STAFF REPORT
KETCHUM PLANNING AND ZONING COMMISSION
MEETING OF SEPTEMBER 9, 2025

PROJECT: Warm Springs Townhomes

FILE NUMBER: P24-063

APPLICATION: Design Review

UTILITY PLAN
WARM SPRINGS VILLAGE SUB 2ND ADD. REV.
BLOCK 4, LOT 3A
LOCATED WITHIN SECTION 14, T.4 N., R.17 E., B.M., CITY OF KETCHUM, BLAINE COUNTY, IDAHO
PREPARED FOR: PRESIDIO VISTA PROPERTIES

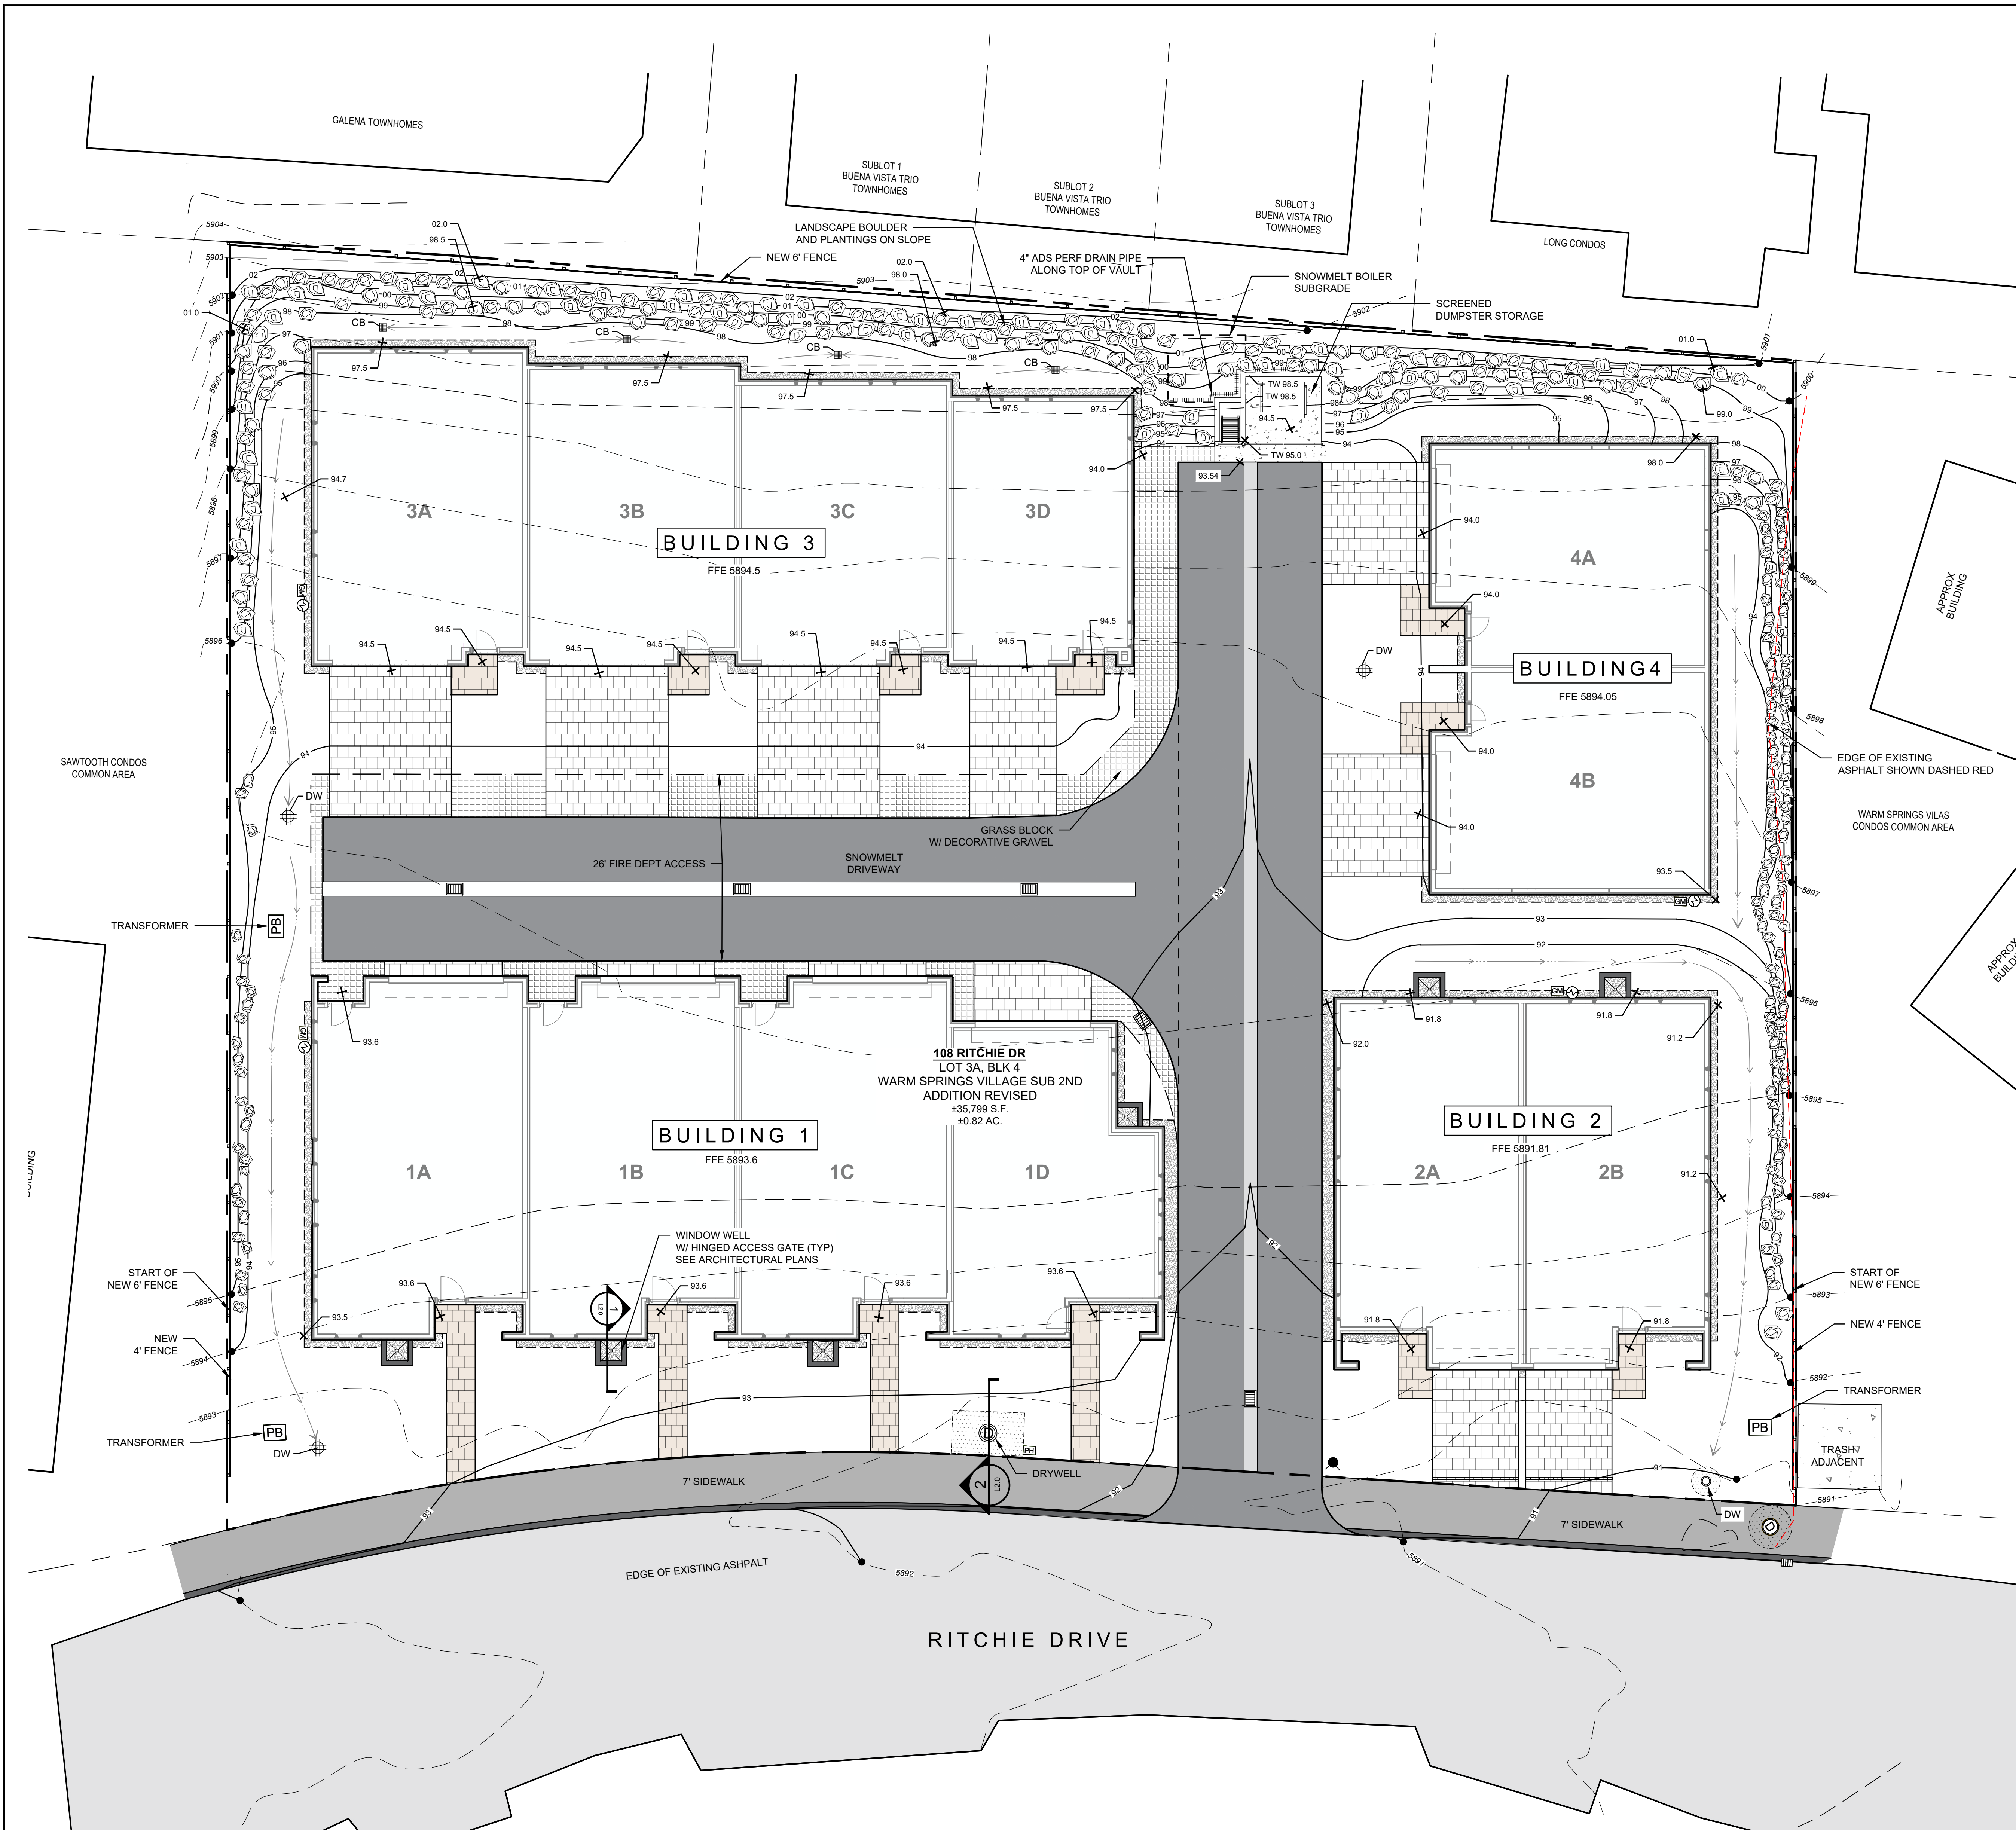
The civil and landscape plans both show proposed locations of transformers to serve the development. KMC 17.96.060.D.2 states *“Utilities shall be located underground and utility, power, and communication lines within the development site shall be concealed from public view”*. Multiple transformers are necessary to serve all 12 units. Per the letter from Idaho Power dated May 17, 2024, the final location of the transformers has not been finalized until further analysis by Idaho Power is conducted. The letter does state that the proposed locations are acceptable, and all may not be needed. Condition of approval #7 states that the development shall utilize internal transformer locations for the development first and that street facing transformers shall only be utilized if no other alternative is feasible. All transformers shall be adequately screened from public view and final screening proposals shall be reviewed and approved by the Planning Department prior to installation.

17.96.060.C.1 - Drainage	Conformance
<i>All stormwater shall be retained on site.</i>	YES Condition #11
<p>Finding: As shown on Sheet C1.00, all stormwater from development surfaces are collected within a series of catch basins and drywells contained on the subject property. The private road is designed to ensure that all surface water from the road drains to catch basins into two on-site drywells. Additionally, there is a catch basin and drywell within the city right-of-way to manage drainage from the sidewalk and street.</p> <p>Pursuant to condition of approval #11, the applicant shall submit final civil drawings prepared by an engineer registered in the State of Idaho that provide specifications for all drainage improvements, for review and approval by the City Engineer and Streets Department prior to issuance of a building permit for the project.</p>

7. The development shall utilize internal transformer locations for the development first. Street facing transformers shall only be utilized if no other alternative is feasible. All transformers shall be adequately screened from public view. Final transformer locations and screening proposals shall be reviewed and approved by the Planning Department prior to installation.

DRAWING NUMBER:
A-104

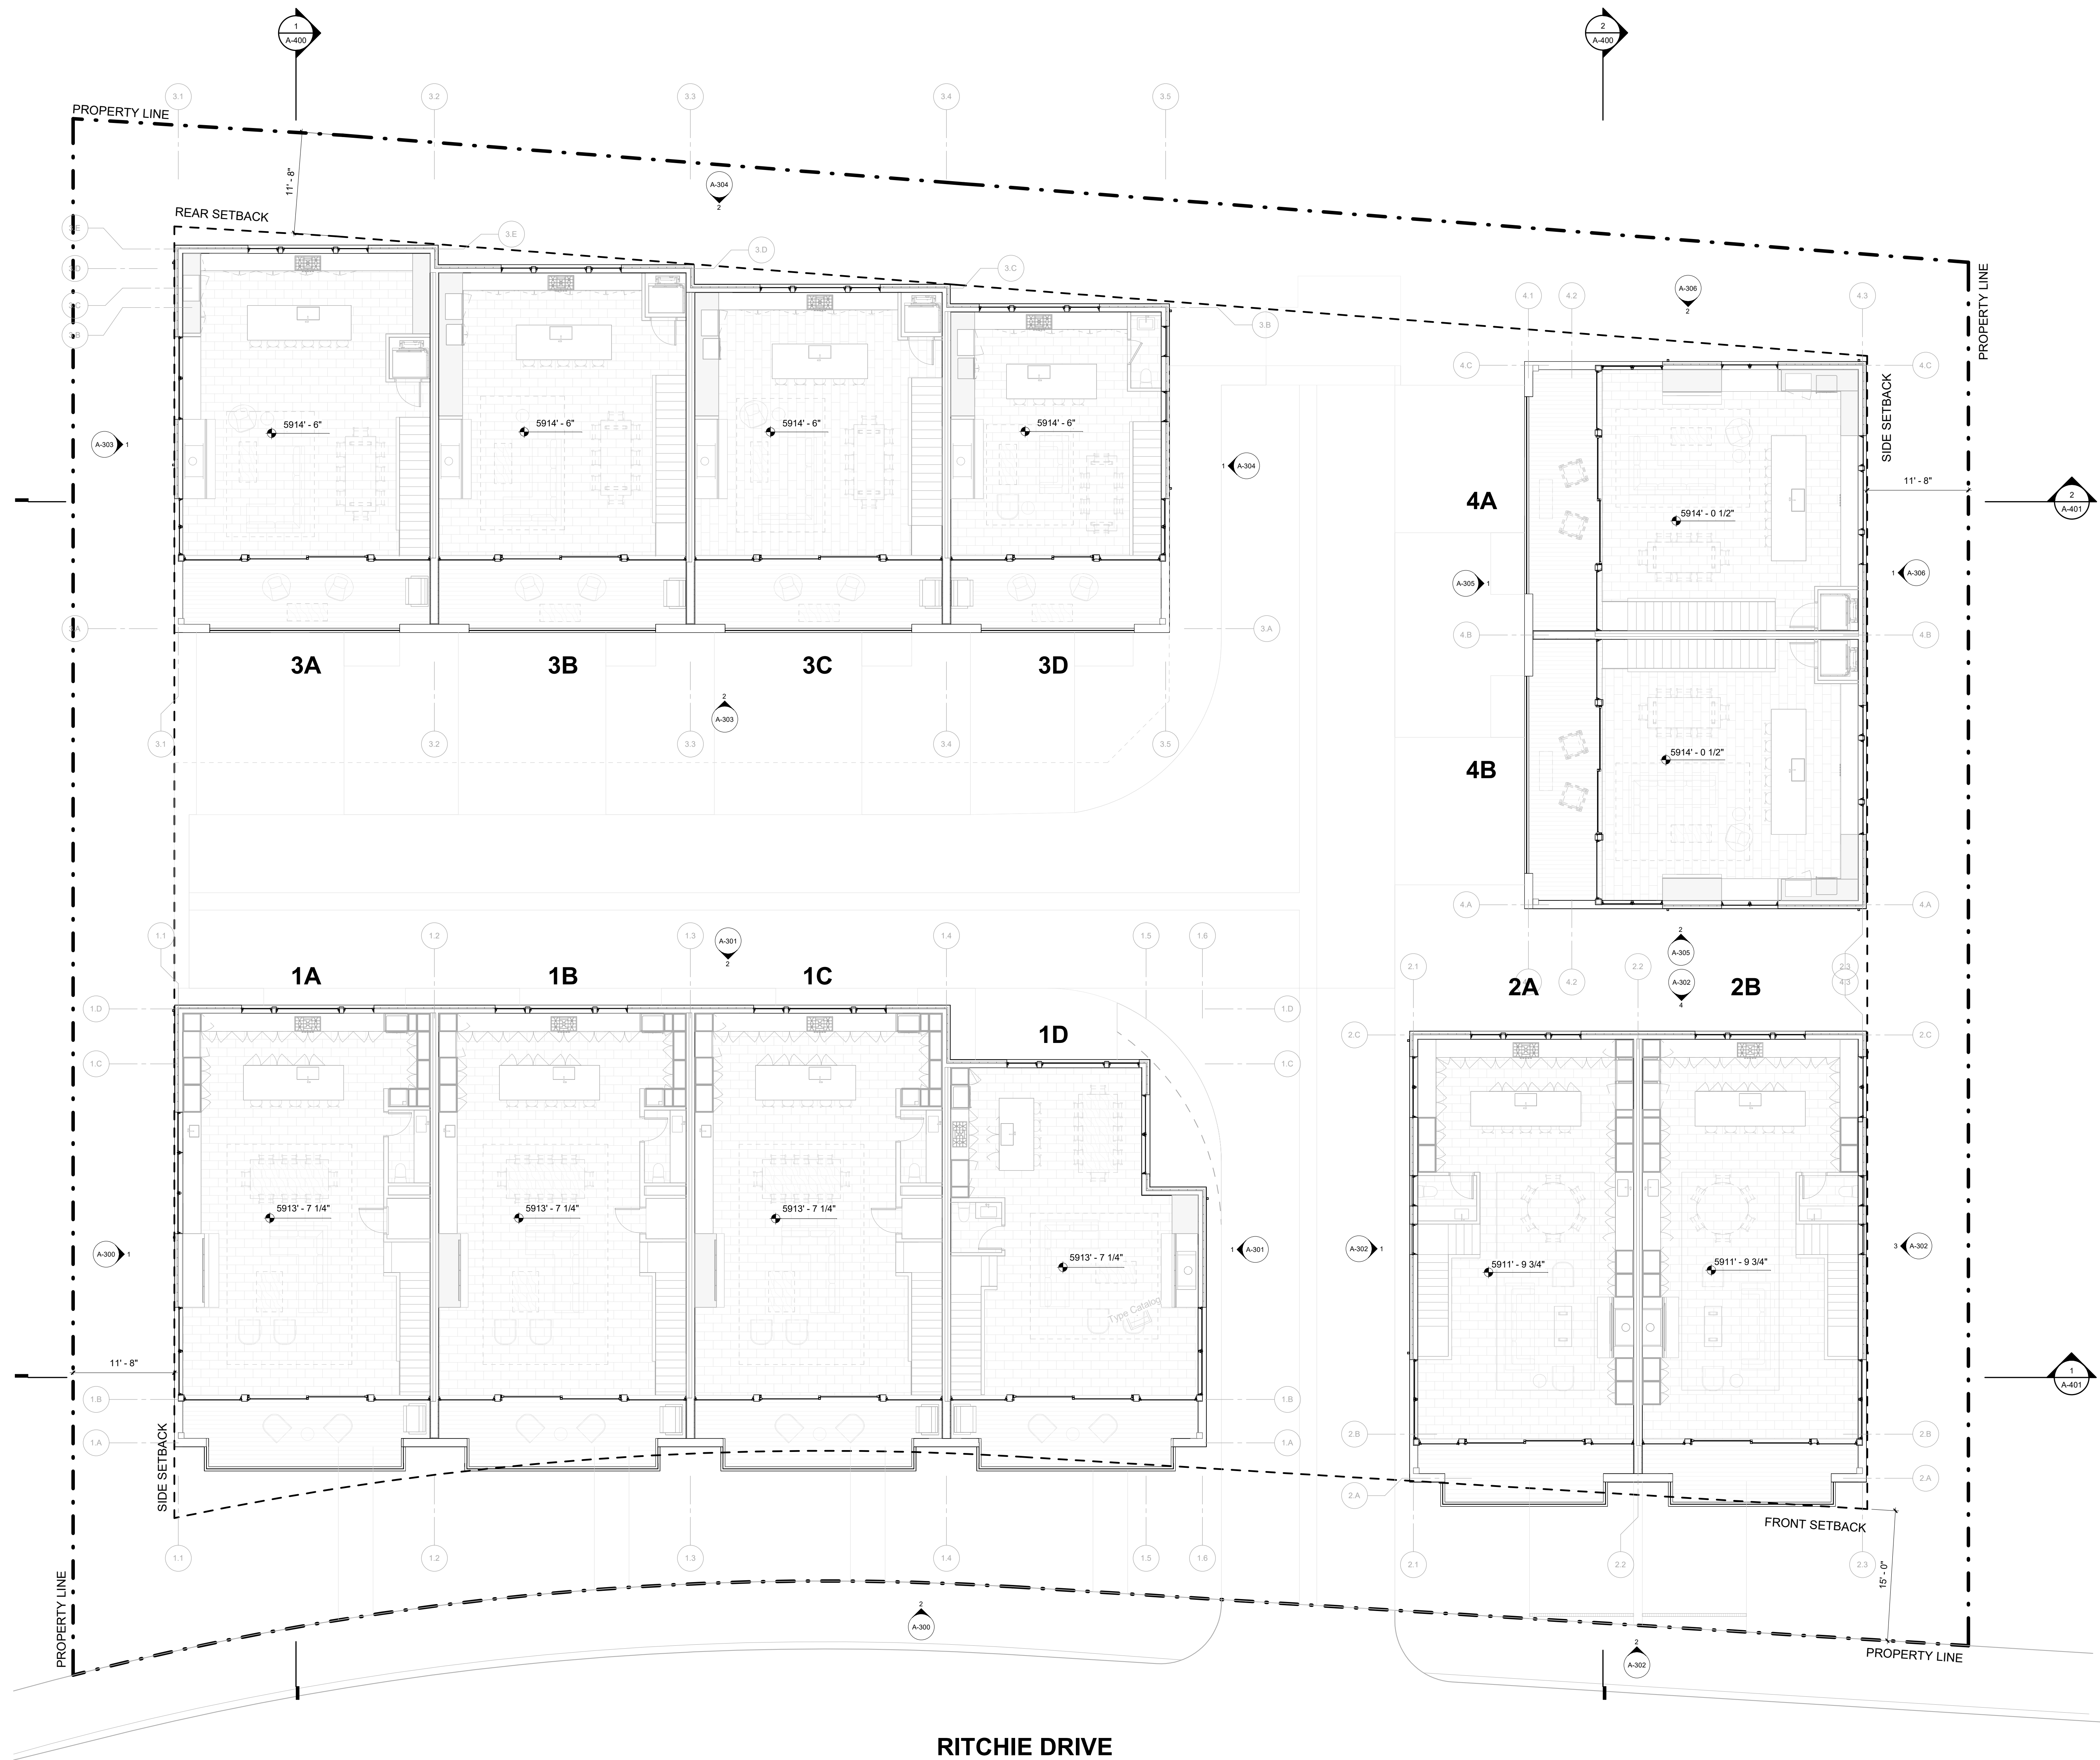
Finding: Sheet A-104 of the development plans shows the roof plan for the development. As shown, two rows of snow fencing is called for on all roofs with gutters and downspouts at all roof eaves to manage roof drainage. None of the roofs or projected decks overhang onto sidewalks where pedestrians gather and setback requirements are adequate for the accumulation of snow if and when roofs need to be cleared during the winter.

2	1/4" = 1'-0"	BUILDING 3 / ELEVATION - WEST
---	--------------	-------------------------------

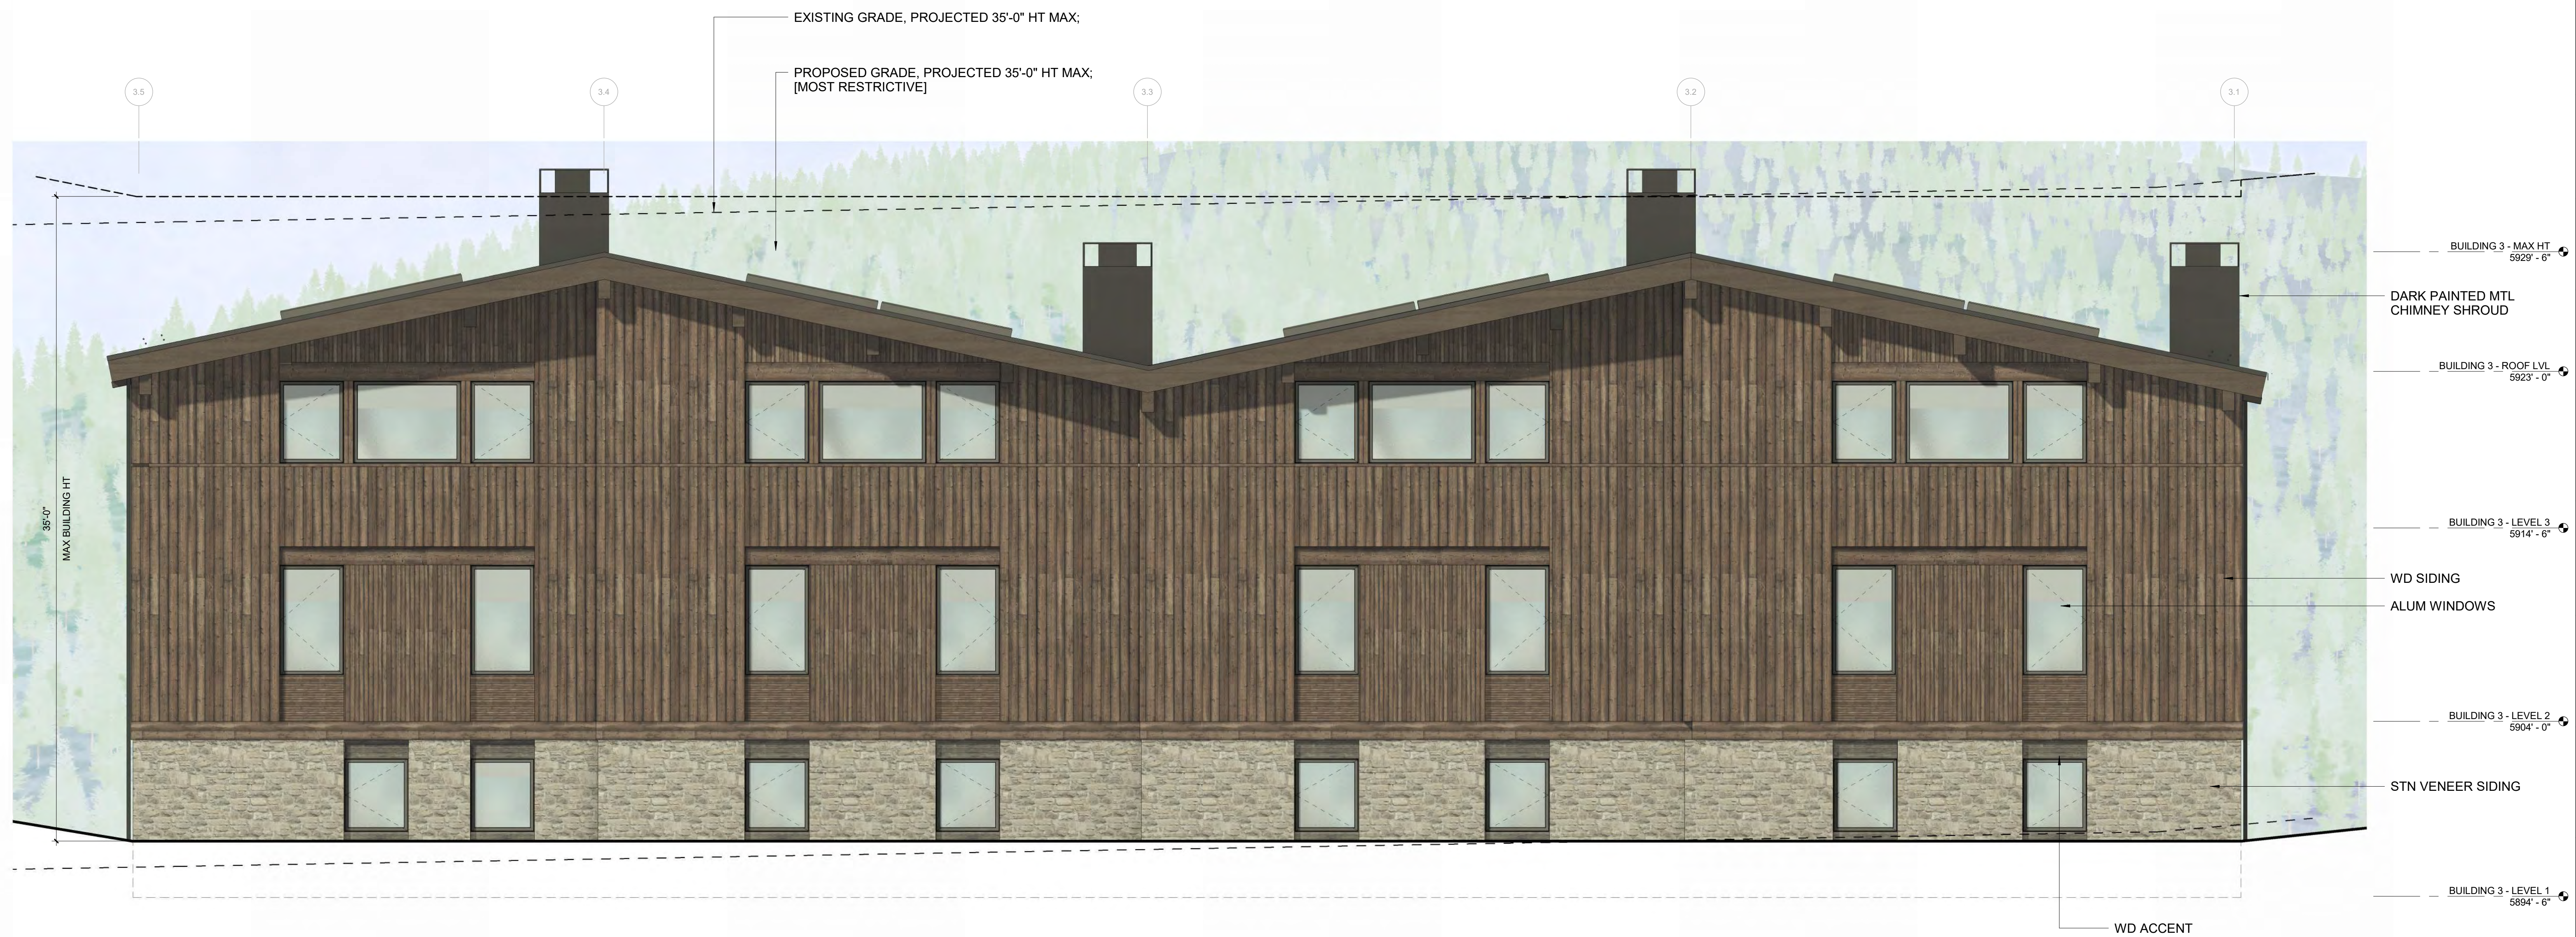
Staff believe these facades to be quite flat and lack architectural features that provide interest and relief from the flat appearance of the structures. It is clear the applicant is drawing inspiration from historic mining structures that often feature tall narrow windows in a repetitive pattern. However, the recessed nature of the windows with minimal trim contributes to the flat nature of the elevations. Staff believe the addition of some key architectural features could assist in adding interest to these elevations. Additionally, the Commission commented on the front façade of Building 3 (see Figures 7 and 8) noting that interior buildings should have similar consideration as the others. Staff agrees that continuity throughout the development is critical and also understands the varying degree of architectural detailing between interior and exterior facing facades. Some considerations for Building 3 may be the reduction of the roof overhang so it is no longer flush with the first and second levels of the building. The applicant could also consider some window trim options to add interest to the facades.

17.96.060.F.5 – Architectural	Conformance
<i>Building walls shall provide undulation/relief, thus reducing the appearance of bulk and flatness.</i>	NO
<p>Finding: There are four buildings within the proposed development, each one with certain aspects of the building visible from public vantage points. Elevations of the buildings are included in Sheets A-300 through A-306. Perspectives from the street are provided on Sheets A-500 through A-505. Buildings 1 and 2 front Ritchie Dr. These elevations have pitched roofs with modest overhangs that do not extend past the cantilevered decks below. The roof detailing also includes exposed beams which is a common architectural feature in the area that softens any sharpness created by the roof overhang. The cantilevered decks, although repetitive along the façade, occur at a separation that accentuates the individual units. The glazing of the second floor is appropriate for the scale of the façade. There are recessions on the ground floor for entrances which also create interest at the street level.</p> <p>However, the side elevations of all 4 buildings and the front elevations of Buildings 3 and 4 lack undulation and relief. See the staff report for further discussion.</p>
